Technical Bulletin – December 2015

VKBD 0162

FORD: Focus 1.4-16V / 1.6-16V
Car model codes: DAW/DBW/DFW/DNW

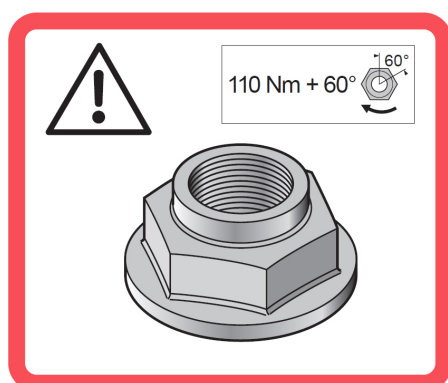
Caution, when fitting the wheel bearing kit VKBD 0162, it's mandatory to use the new nut included in the kit. Never reuse an old nut!

SKF has decided to change the nut in VKBD 0162, due to updated FORD OE recommendations.

Note: The included nut at kit VKBD 0162 has a new design and needs a different torque compared to the old design. It is crucial to follow the instructions when torquing the new nut since this is a **safety aspect**. See torque values stated at the warning label below.
